**Addendum 4**  
**Solicitation 23-AA07**  
**Duluth Coastal Infrastructure Rehabilitation Project**

**Re: Duluth Coastal Infrastructure Rehabilitation – Addendum #4**

AMI Project # 211016

SHEET:  
**L202**

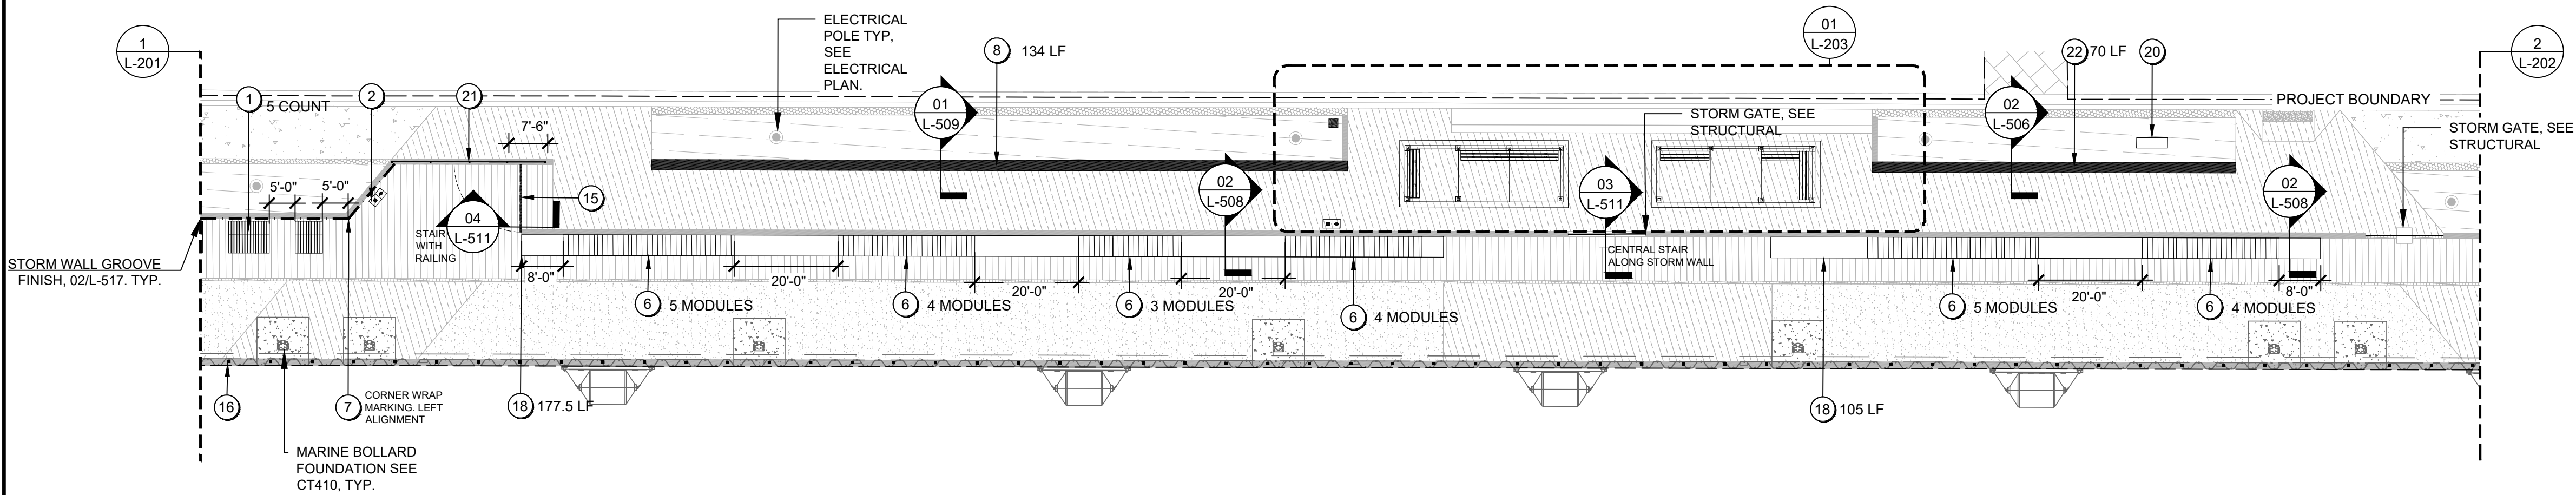
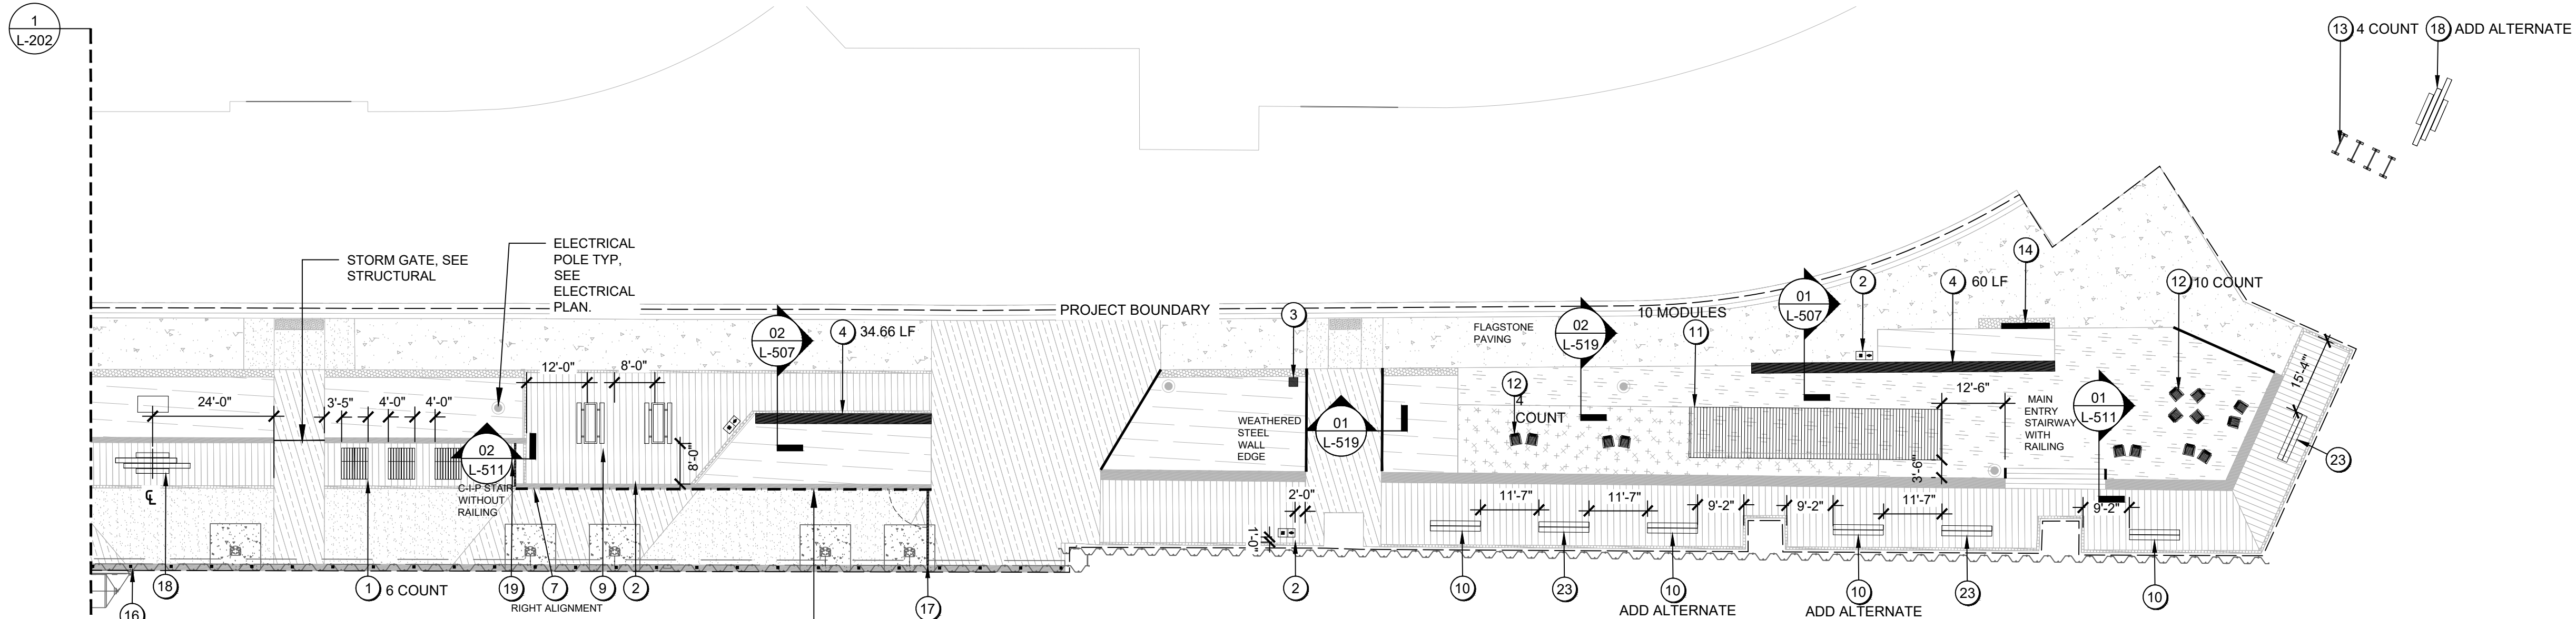
On sheet L201 there was an annotation error. The confirmed distance of the wall mounted monument sign is to be 17' from the curved radii. On sheet L202 the confirmed manufacturer for the Adirondack chairs is LOLA and the product is Adirondack Chair Flat or approved equal as specified in the construction documents.

On sheet L202, the bike rack near the blue bridge shall be surface mounted with the interlinked version. Other bike racks on the site are embedded. Revised sheets are attached to this addendum.

**L505**

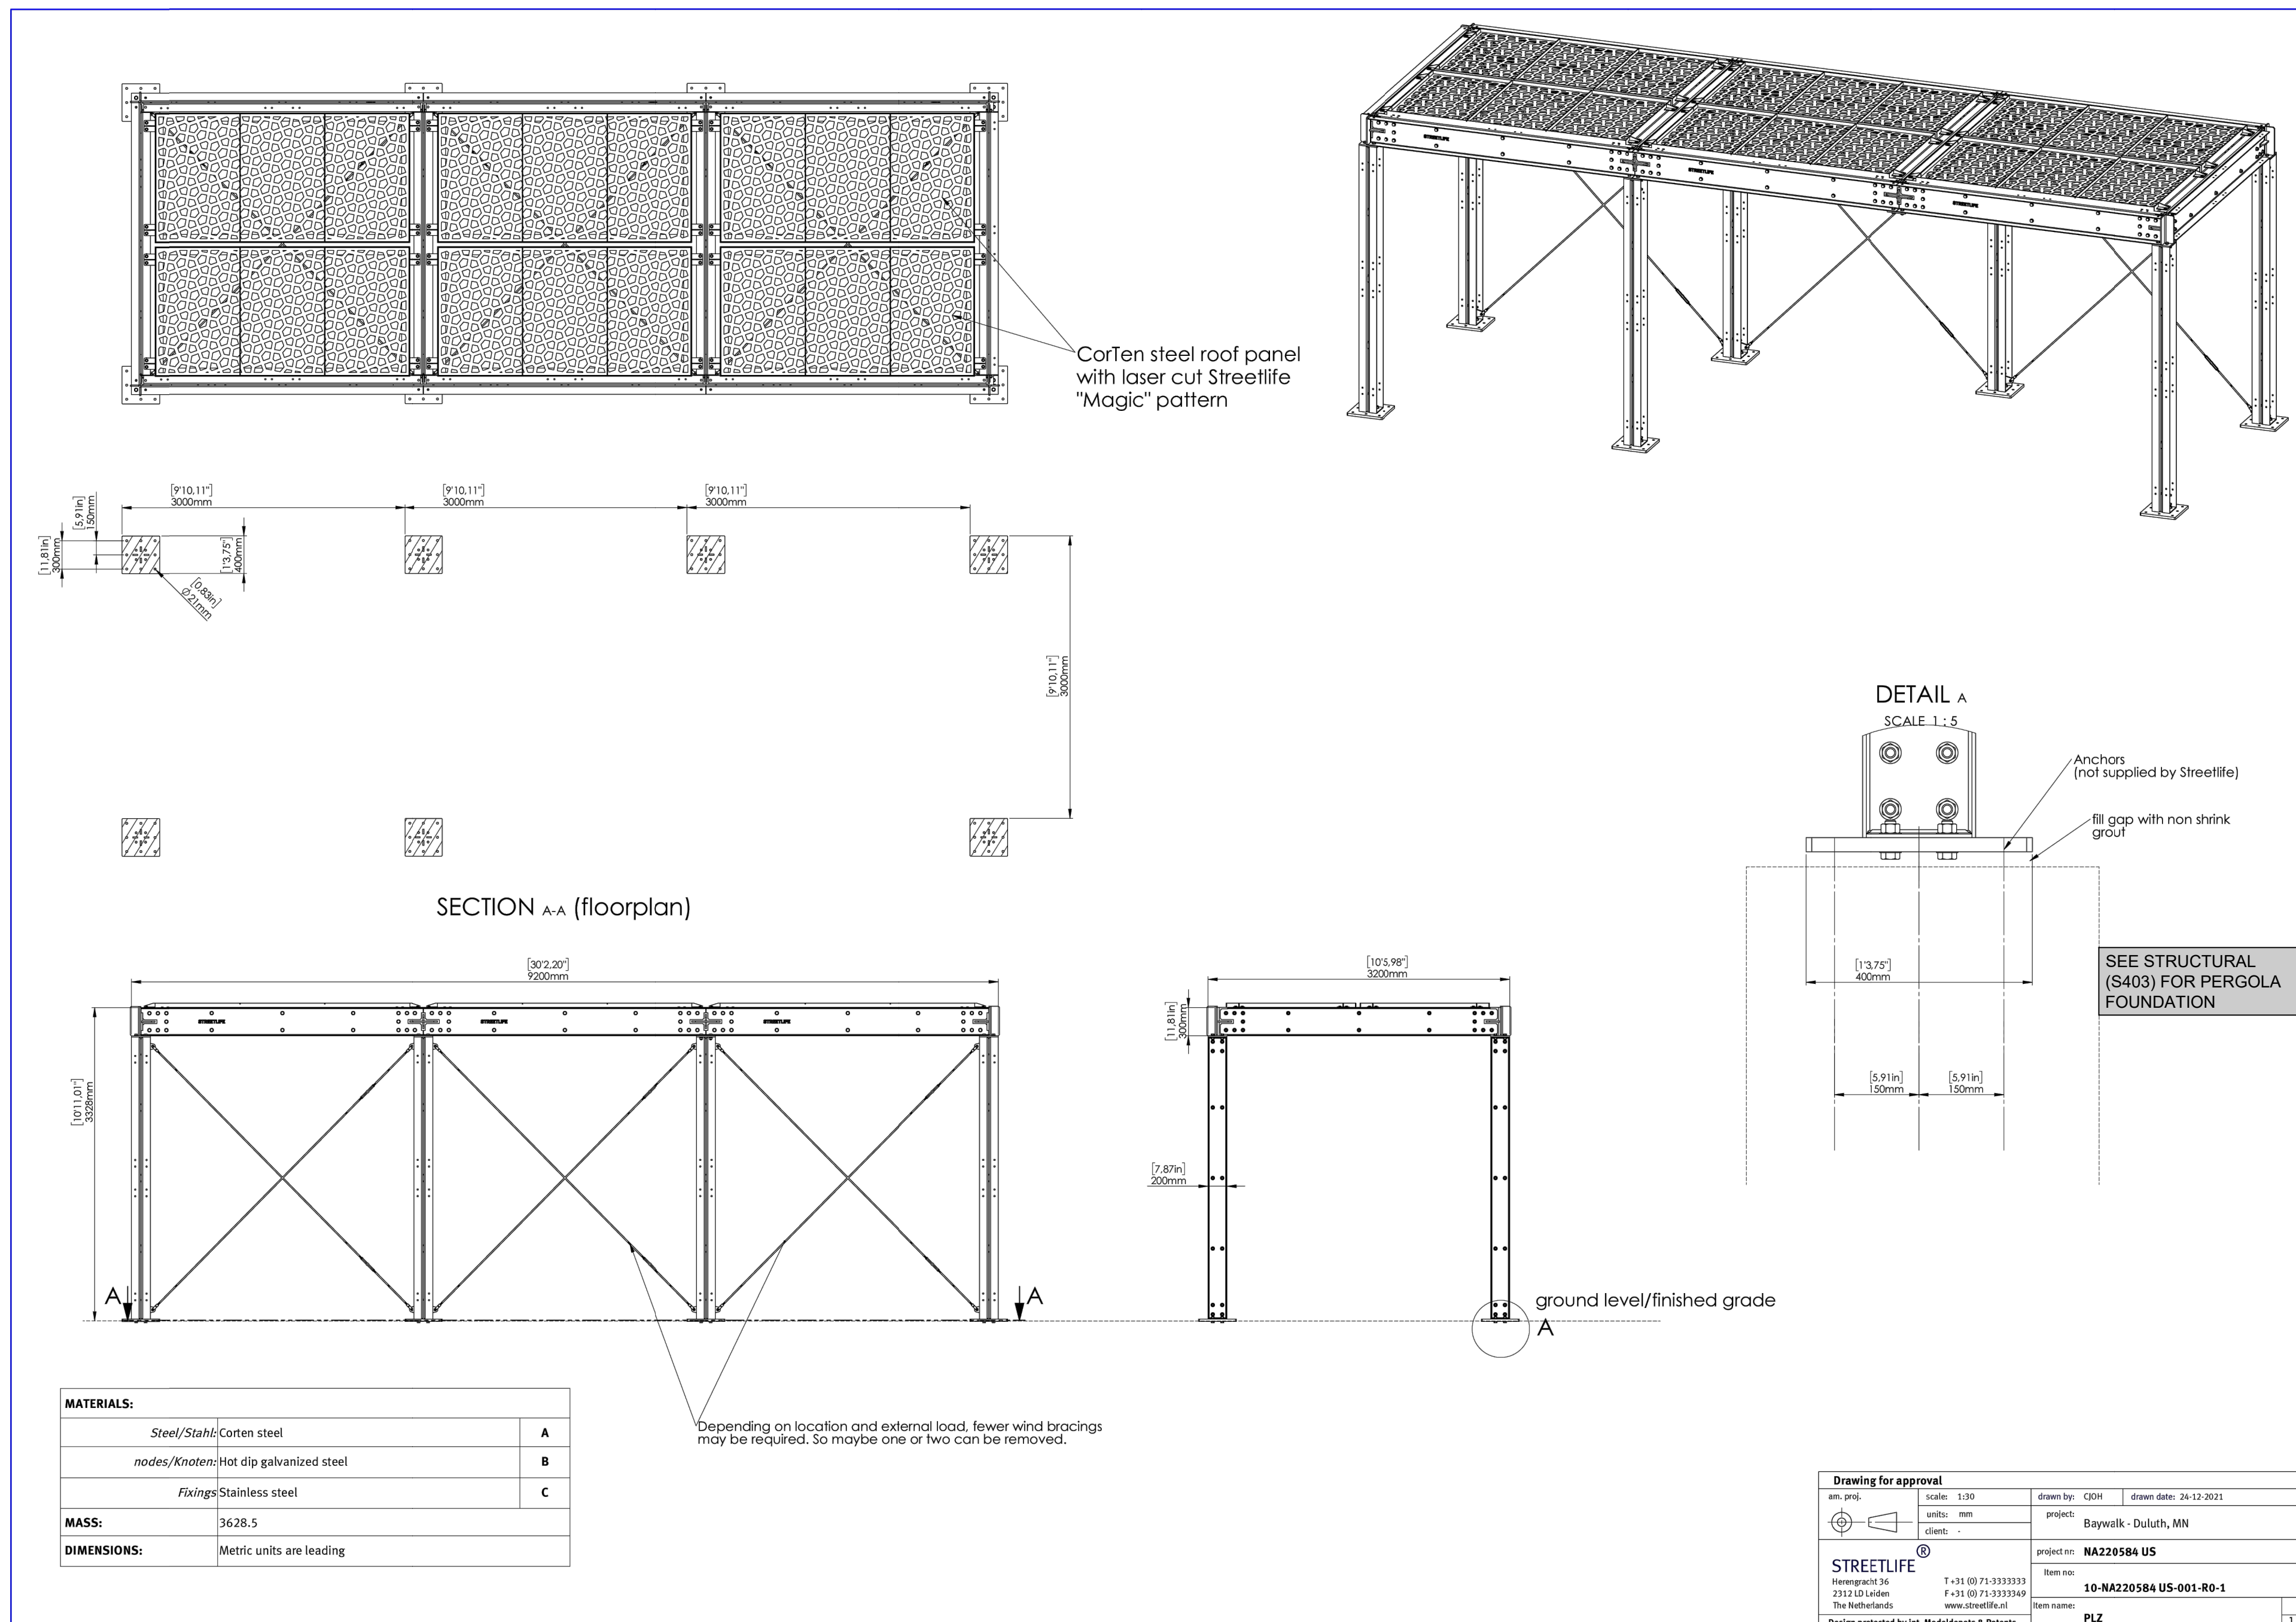
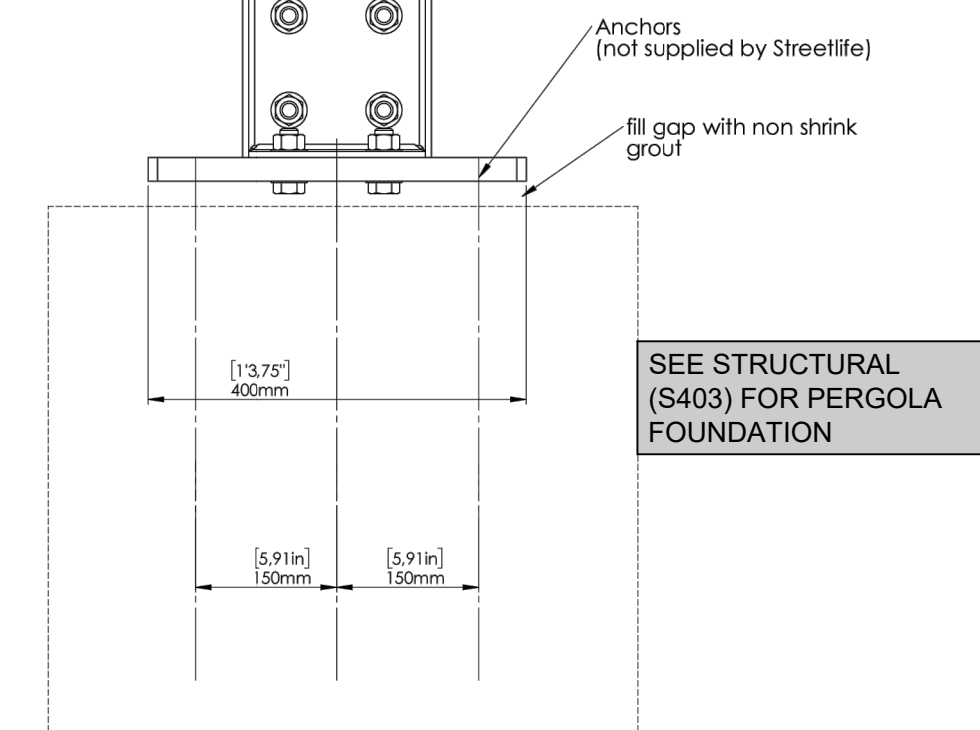
The preferred pergola manufacturer and specifications have been updated on sheet L502. This updated sheet is included in this addendum.
